Site Accessibility Evaluation

Americans with Disabilities Act And Title 24 And Part 2 - California Building Code

**City Hall and City Hall Annex
735 Anacapa St
Santa Barbara, CA 93101
Accessibility Evaluation
Inspection Date: 08/17/2023
Inspectors: Scott Saddlemire**

Report Date: 11/03/2023

Finding: 2

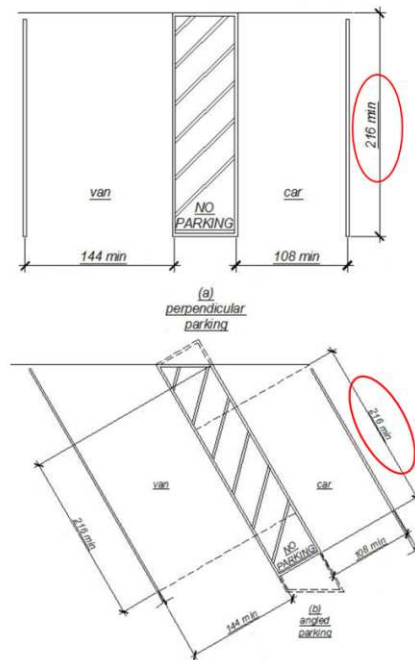
The accessible parking stall is not long enough.

angled stalls, no van, sign not
aling with stall

See the figure for angled stalls.

See additional pics for stalls and access aisle that are non compliant

Exterior: Parking**Lat/Long:** [34.42029, -119.6986]**Finding: 4**

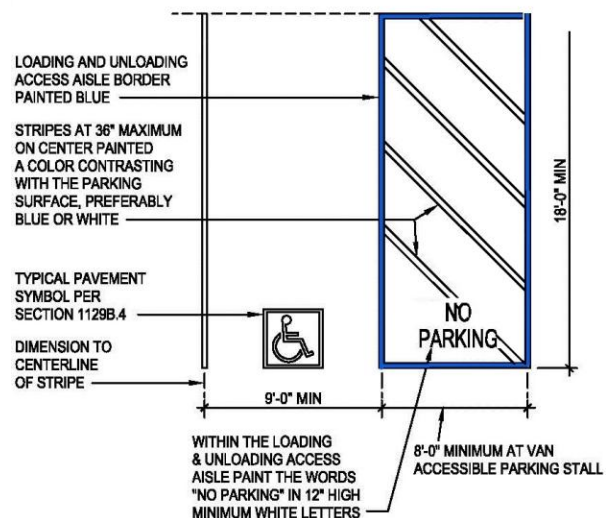
The access aisle adjacent to the accessible parking stall is not the minimum required length.

angled stalls, no van, sign not
aling with stall

access aisles are not long enough for the angled parking stalls

Finding: 5

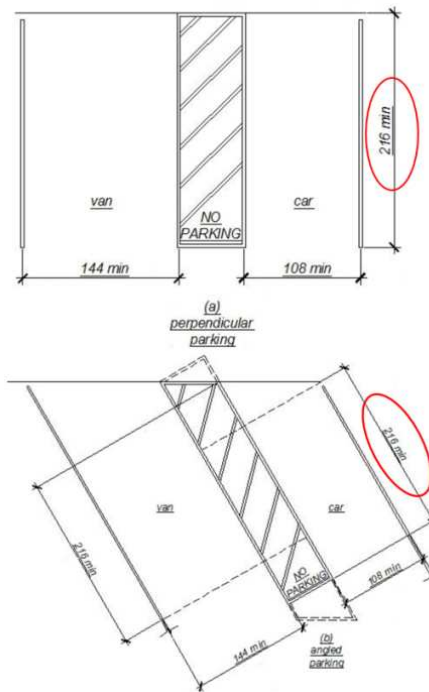
The accessible parking stall is not long enough.

Exterior: Accessible routes**Lat/Long:** [34.42029, -119.6986]**Finding: 9**

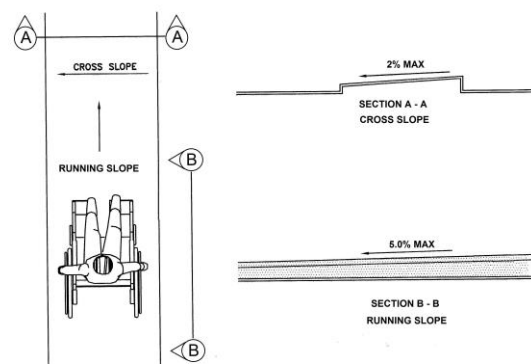
The accessible path of travel between the building entrance and the accessible parking has cross slopes greater than 2%.

Exterior: Accessible routes**Lat/Long: [34.42029, -119.6986]****Finding: 11**

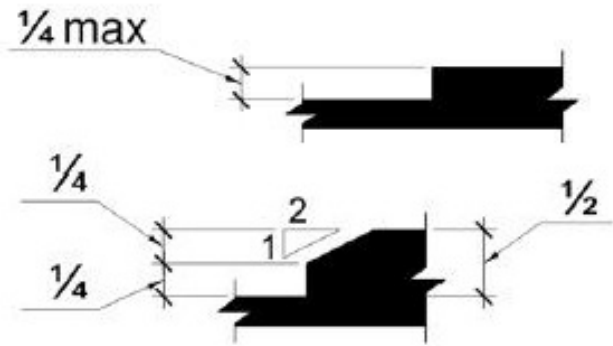
The walkway contains abrupt vertical edges and/or variations over 1/4 inch.

2010 ADAS Section: 303.3, 303.2 **no domes**

Exterior: Accessible routes**Lat/Long:** [34.42029, -119.6986]**Finding: 12**

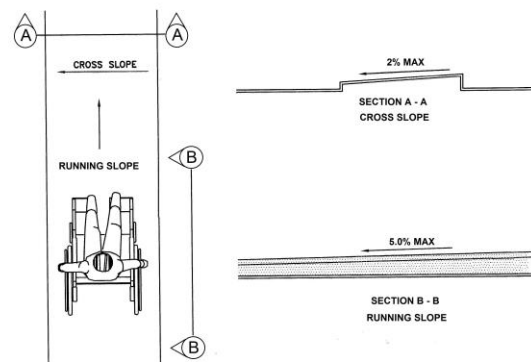
The accessible route between the building entrance and the accessible parking has running slopes greater than 5% and has not been constructed as a ramp (i.e. handrails, edge protection, etc.).

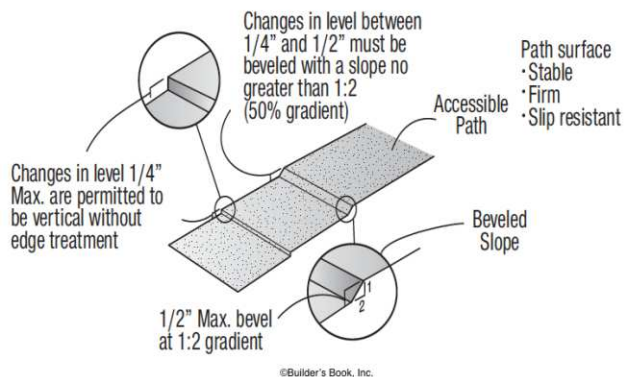
The ramp contains surface materials that do not provide for a stable, firm slip resistant surface.

slope changes

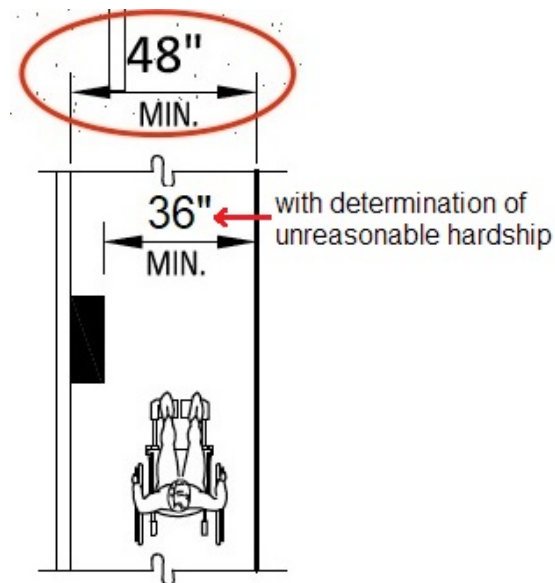
The route of travel does not provide the required minimum width.

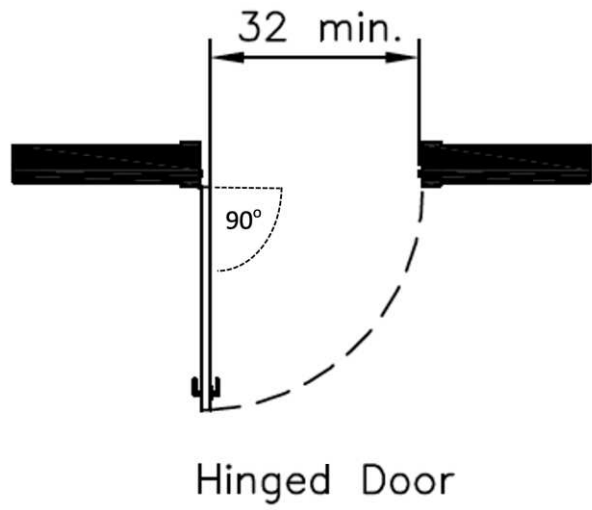
The door opening does not provide at least 32 inches between the face of the door and the opposite stop.

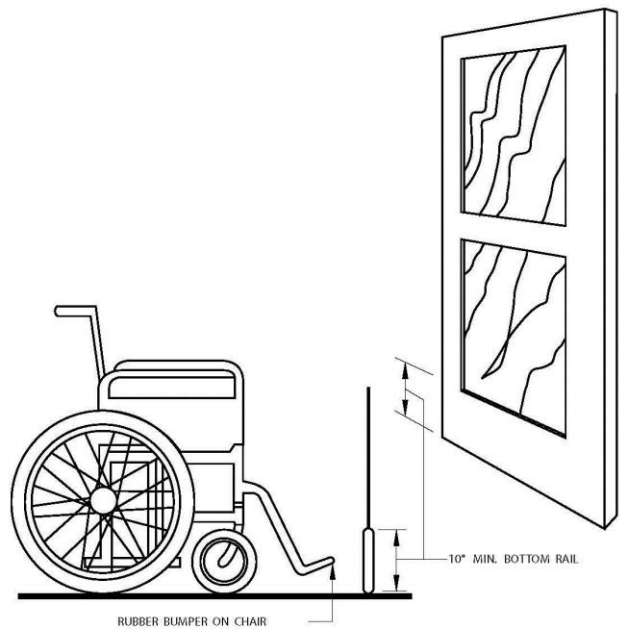
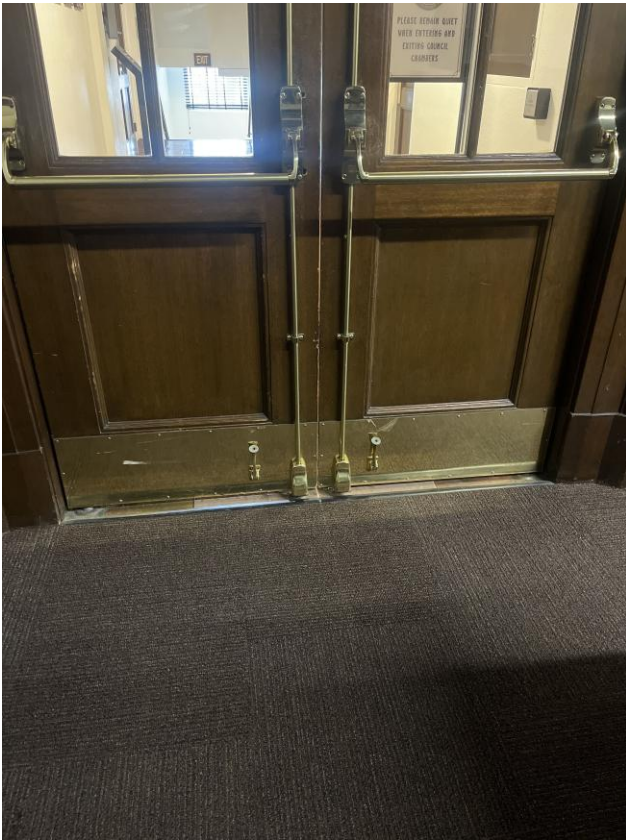
automatic doors did not work

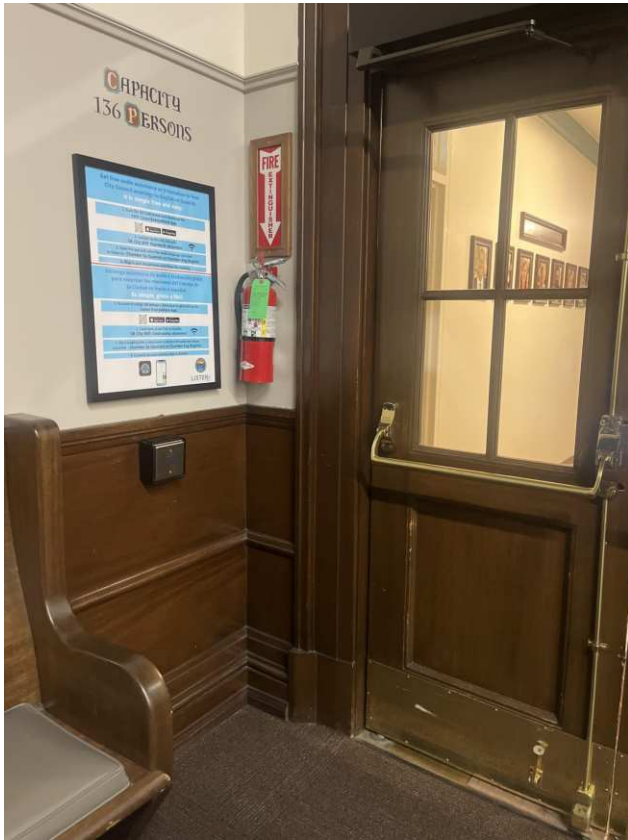
not working

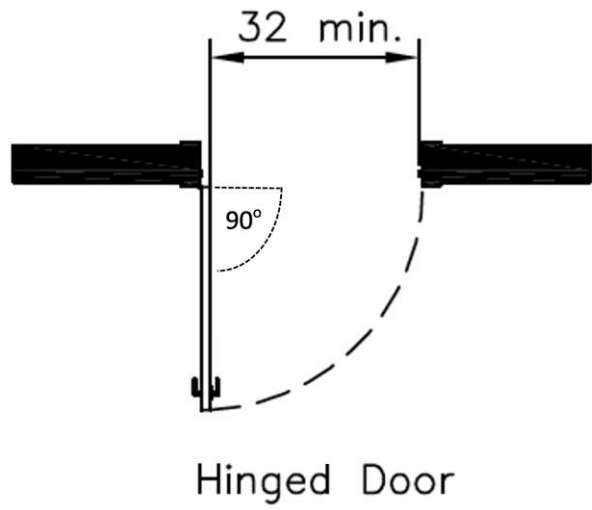
The door opening does not provide at least 32 inches between the face of the door and the opposite stop.

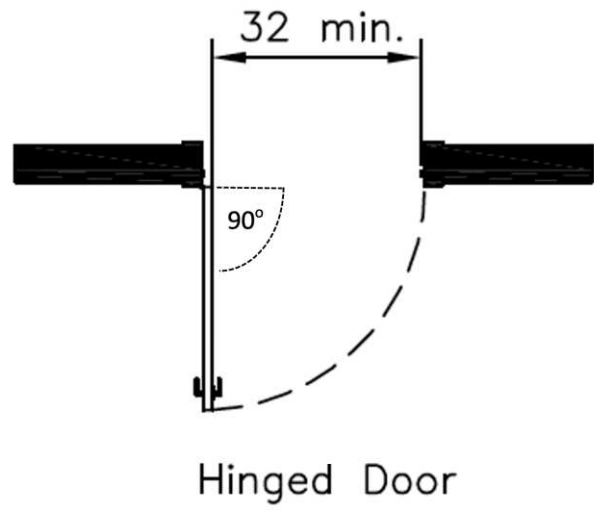
The door opening does not provide at least 32 inches between the face of the door and the opposite stop.

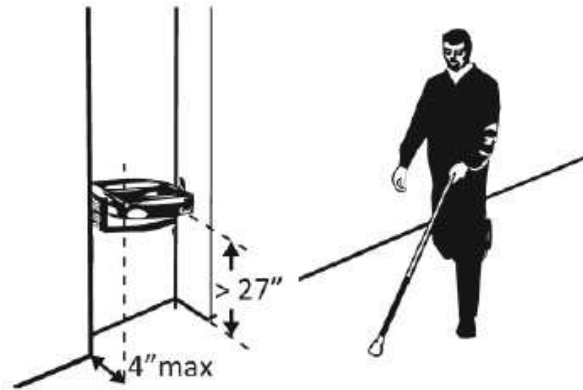
No cane detection needed if set exactly at 27"
(unless standing person drinking fountain is added)

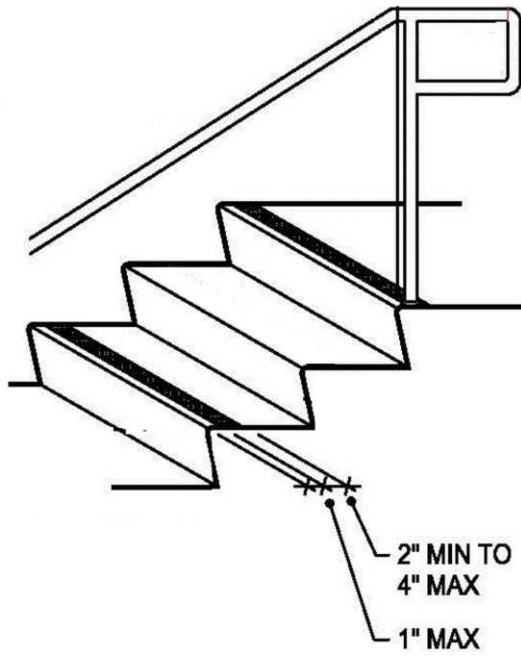
The handrails are not at the correct height.

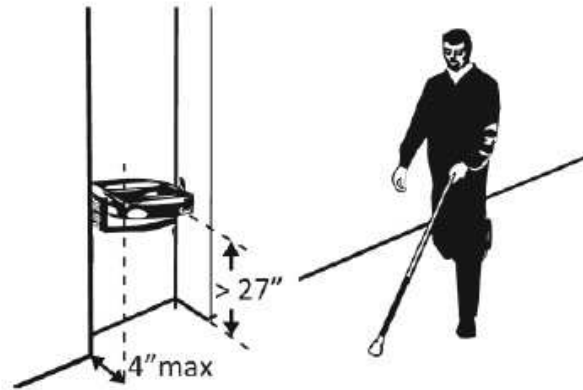
not an issue is set exactly at 27" unless standing fountain is added
